# SERVICE BULLETIN

Classification:	Reference:	Date:
EC16-026	NTB16-086	August 25, 2016

## 2013-2015 SENTRA; ENGINE TURNS OFF OR HESITATES WHEN ACCELERATING FROM A STOP DURING HOT AMBIENT TEMPERATURES (+100° F)

**APPLIED VEHICLE:** 2013-2015 Sentra (B17)

Figure A

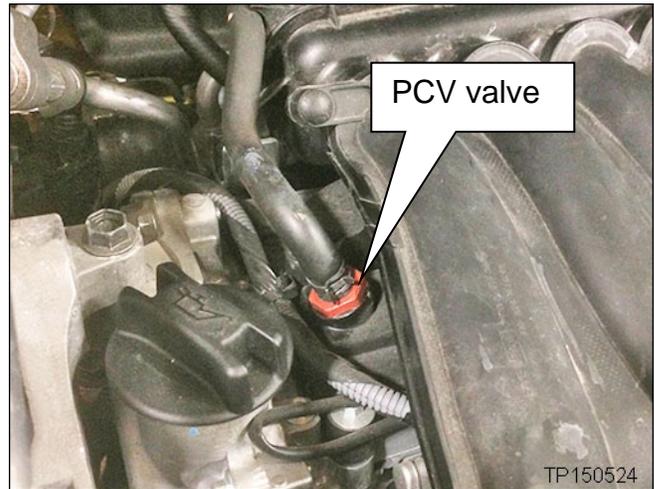
**If PCV valve is orange, as shown in Figure A:**

- Replace the PCV valve.
- If needed, refer to the Electronic Service Manual ESM, section EM-Engine Mechanical, for replacement information.
- Use the new PCV valve listed in the Parts Information.
- The new PCV valve is “black” color.

DESCRIPTION	PART NUMBER	QUANTITY
PCV Valve (Black Color)	11810-6N202	1
